<h1 style="margin: 0;">TECHNICAL BULLETIN</h1> <h2 style="margin: 0;">AC - 08</h2>
---	--

DATE: FEBRUARY 14, 2001
MODEL YEAR: 1999 AND AFTER
CHASSIS MODEL: UD1200/UD1400/UD1800CS
ENGINE MODEL: FD46TA
BULLETIN #: AC-08
FILE IN THE ACCESSORIES SECTION OF THE TECHNICAL BULLETIN BINDER

ZEXEL AIR CONDITIONER CONDENSER FAN RELAY SUB-HARNESS

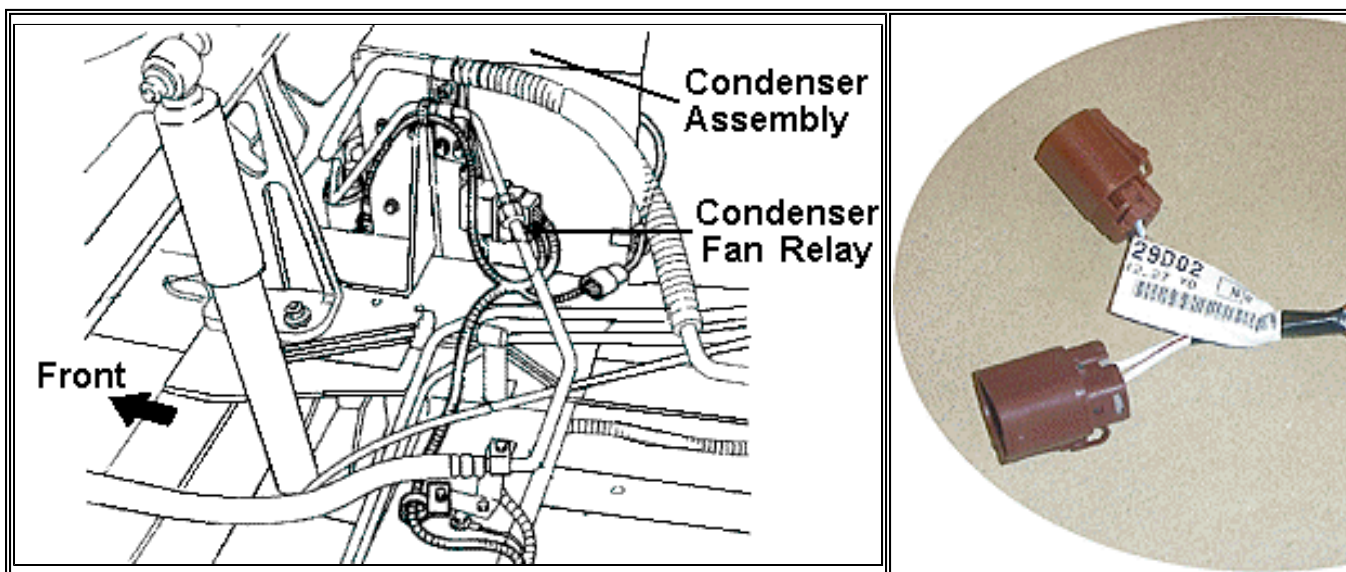
Analysis of failed condenser fan relays indicate that the armature contacts may oxidize which may result in the loss of electrical power to the condenser fan motor. Whenever this condition occurs, the air conditioning quits cooling due to the loss of condenser fan motor operation.

It is recommended to install the condenser fan relay sub-harness whenever the relay is replaced. Install the sub-harness between the chassis harness connectors and the relay. When installed, the sub-harness becomes a jumper between the chassis harness and the relay.

ORIGINAL PART NUMBER:	25230-0T001	Condenser Fan Relay
NEW PART NUMBER:	24004-29D02	Sub-harness
